# **Response to Requests for Additional Information for the Review of the ARCADIA<sup>®</sup> Reactor Analysis System for PWRs Methodology Description and Benchmarking Results Topical Report**

ANP-10297Q1NP  
Revision 0

AREVA NP Inc.

The ARCADIA® Topical Report [1-1] was submitted to the US Nuclear Regulatory Commission for review in March 2010. A draft set of Requests for Additional Information (RAI) was released by the NRC in December 2010. This document addresses the AREVA NP Inc. responses to a subset of these RAIs.

Figure 7.3-2: Heavy Reflector Geometry

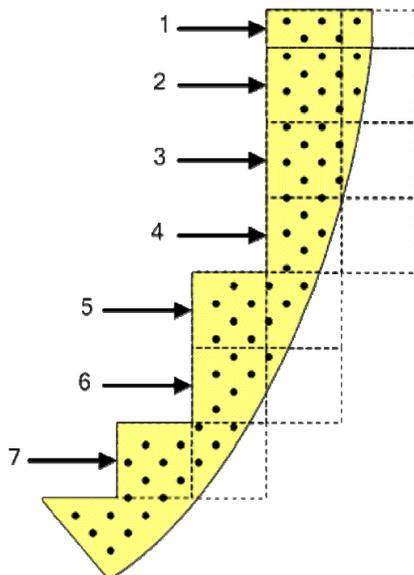
**RAI 22** For “heavy reflectors”, (reflectors comprised of a thick steel shroud and low moderation inside the core barrel), the water scattering cross sections are calibrated with factors “deduced from the comparison of the 2D power density distribution calculated by ARTEMIS with the corresponding reference MCNP result”. The methodology used to “deduce” these factors should be documented and some justification should be made as to the application of the modified scattering cross section to other plant/fuel types. A quantification of the magnitude of the calibration should also be provided. [Page 7-4]

The 1D spectral geometries with reflective boundary conditions used for deriving the cross sections for the radial reflector neglect transverse leakage (2D) effects. For the heavy reflector this leads to discrepancies between ARTEMIS and MCNP reactor calculations when using non-adapted reflector cross sections.

An iterative procedure, a variant of the simulated annealing algorithm, was developed for the purpose of deriving adaptation factors for the heavy reflector cross sections. The procedure adapts the microscopic slowing-down cross section of H<sub>2</sub>O until spread and standard deviation of the differences of the normalized core wide power density distribution of ARTEMIS and the fission rate distribution of MCNP are minimized. In ARTEMIS the normalized power density and fission rate distribution is consistent.

Two types of adaptation factors were found to be sufficient for avoiding heavy reflector induced in/out or azimuthal trends, one for non in-side (edge) and one for re-entrant (corner) reflector nodes. The classification of the heavy reflector nodes is (see Figure 7.3-2 of the Topical Report):

reflector nodes 1, 2, 3, 4, 6 → edge  
reflector nodes 5, 7 → corner

The resulting adaptation factors are 3.02 for the edge reflector nodes and 4.01 for the corner reflector nodes.

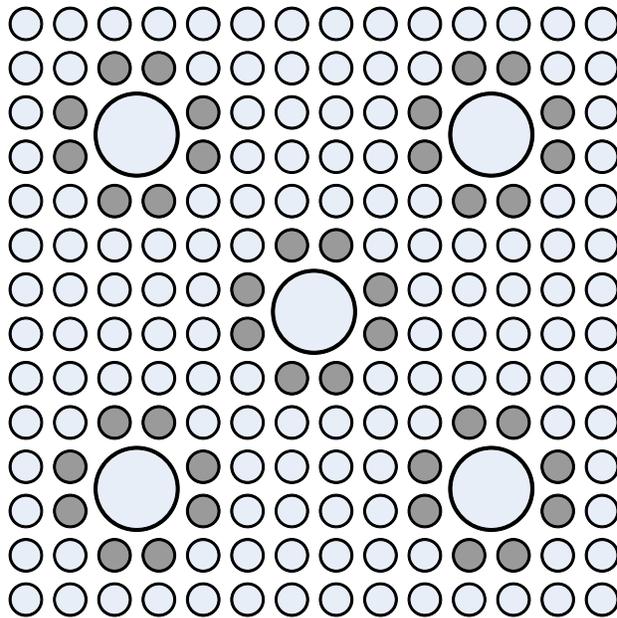
**RAI 24** Figures 7.3-4 and 7.3-5 look like full core but the documentation states that MCNP was run with octant symmetry. Why are full core results provided?  
[Page 7-5]

The represented cores are octant symmetric. Nevertheless, the ARTEMIS Calculations were performed in full core geometry. For direct application of existing scripts the MCNP results were unfolded to full core geometry.

Figure 28-G1-1: Plant G1 Cycle 26 Critical Boron Concentration vs. Burnup

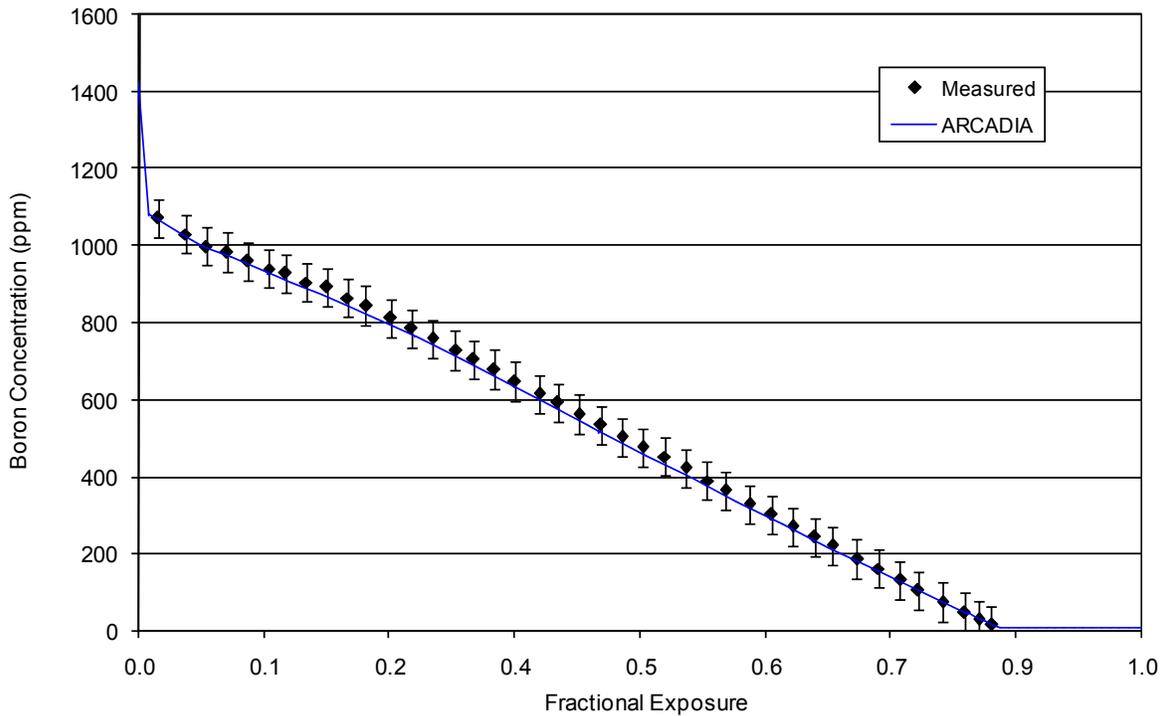
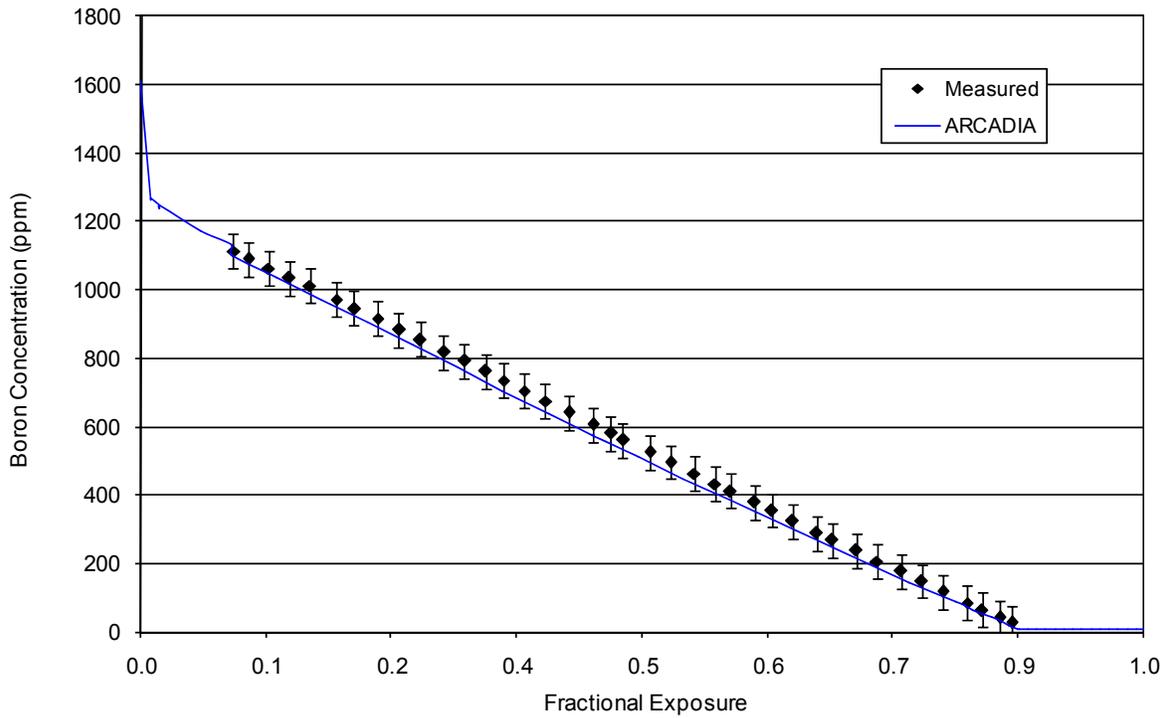
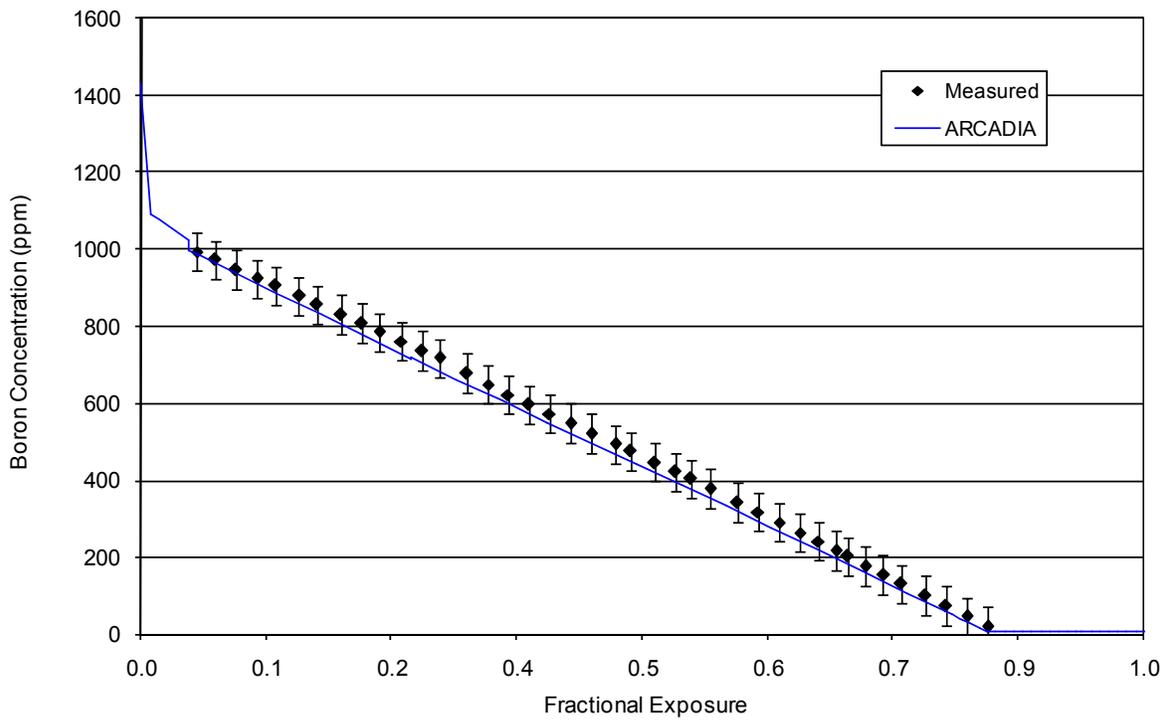
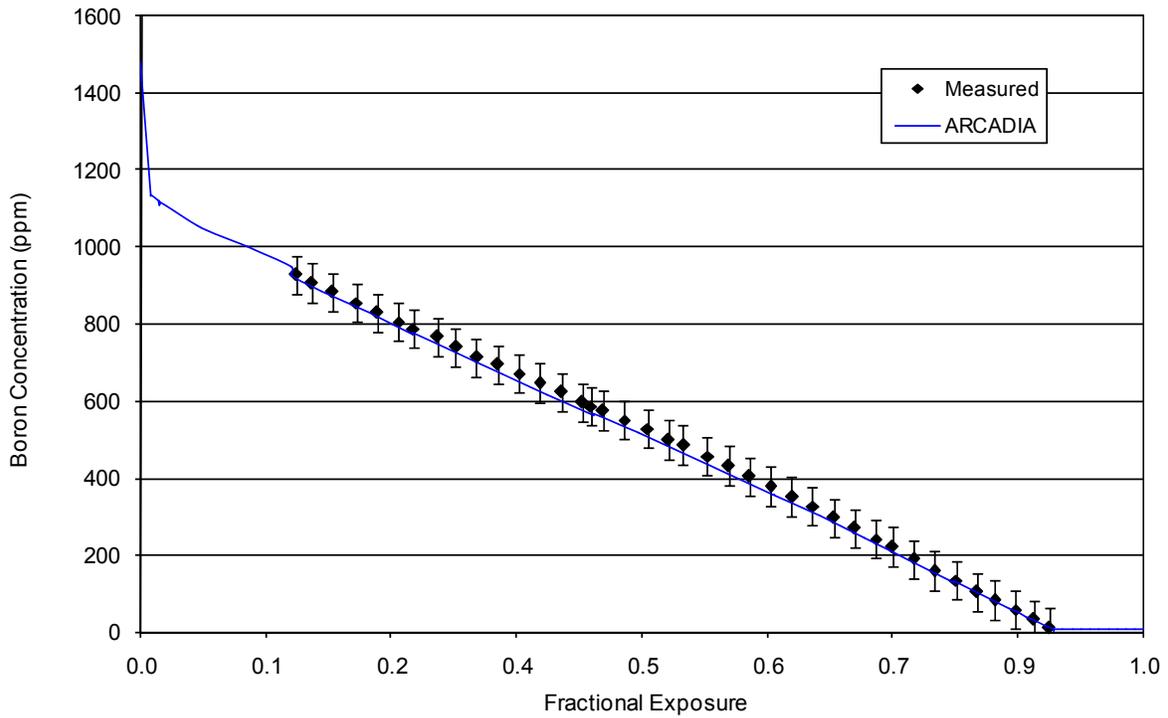
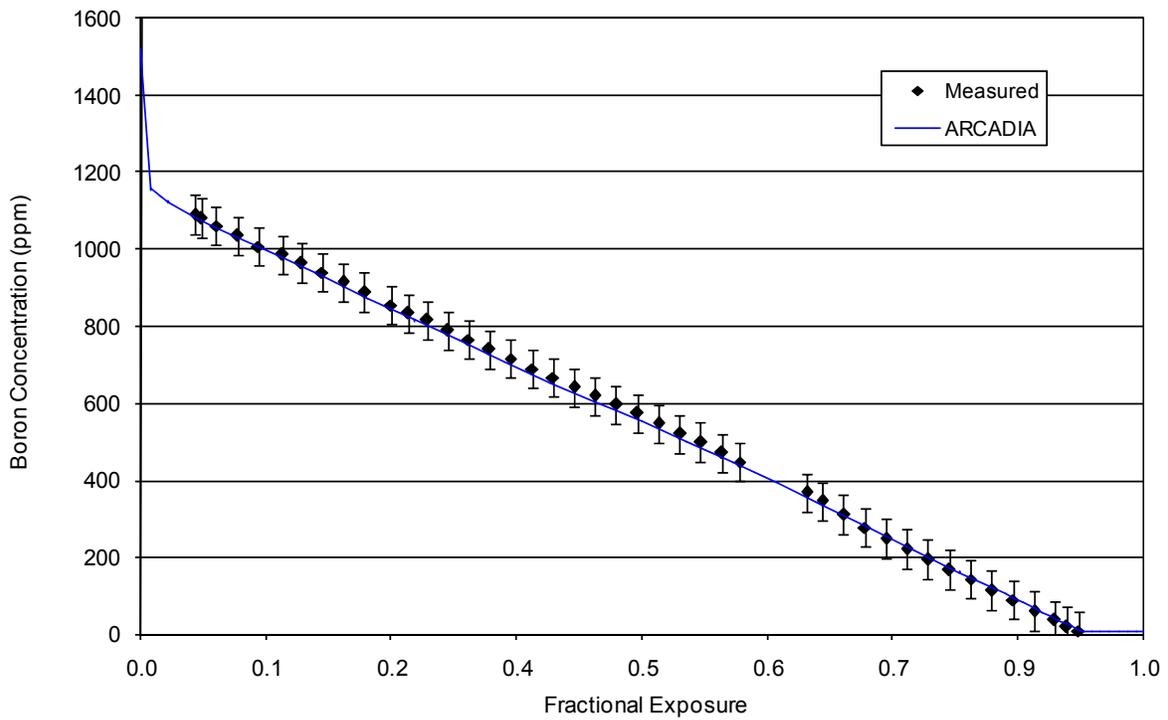
**RAI 28** Plant G1 Cycle's 27 and 28 had a BOC B10 abundance of 19.2%. Also, Cycle's 29 and 30 used enriched B10 at about 30%. The report states that the Cycle 26 HZP boron measurement "may be suspect because of the B10 isotopic abundance was not measured". However, there are no unexpected comparisons at BOC HFP, which indicates that no additional B10 correction should be necessary at HZP. The report does not clearly describe which boron measurements are adjusted for B-10 content, and which are not. B10 corrections, both at HZP and HFP (i.e. B-10 depletion, if included) should be applied consistently for all cycles and should be clearly documented. [Page 10-31,1035]

Erroneously the critical boron adjustment in Table G1 10.3.4-1 and in Figure G1 10.4.4-1 of the Topical Report for Cycle 26 was applied to the calculated values to make them relative to the measured B-10 abundance instead of using the assumed measured B-10 abundance to adjust the measured critical boron concentrations such that they are relative to concentrations with natural boron. The values have been updated and are presented in Table 28-G1-1 and Figure 28-G1-1 (see below).

Moreover, in the Tables and Figures of Appendices G1 and G2 an inconsistency in the results has been corrected. The B-10 abundance of natural boron was assumed to be 19.74 a/o when adjusting the measured values, whereas ARTEMIS uses the value 19.9 a/o. To compare boron concentrations directly it is necessary that the adjusted measured boron concentrations correspond to the ARTEMIS B-10 abundance, so in the following tables and figures the measured boron concentrations have been adjusted to correspond to a B-10 abundance of 19.9 a/o.

These corrections have been applied and are shown in Table 28-G1-1, Table 28-G2-1, Figures 28-G1-1 through 28-G1-5 and Figures 28-G2-1 through 28-G2-5.
